Access Compliance Report Public Rights-of-Way (Curb Ramps)

Main Street: WASHINGTON_AVE Cross Street: JEFFERSON_ST Location: NW

ADA ID: RPRK210930181110 Ramp Type: Type 1 - Perpendicular Diagonal Initial Pass/Fail: Fail Overall Compliance: No Severity Score: 20

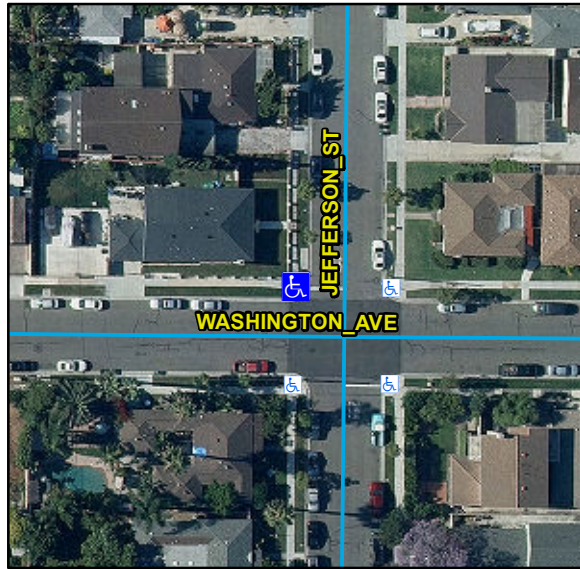
R304.2.2, R204.3, R304.5.1, R304.5.3, STD 1115

Remove & Replace Curb Ramp With Two New Directional Ramps or Equivalent.
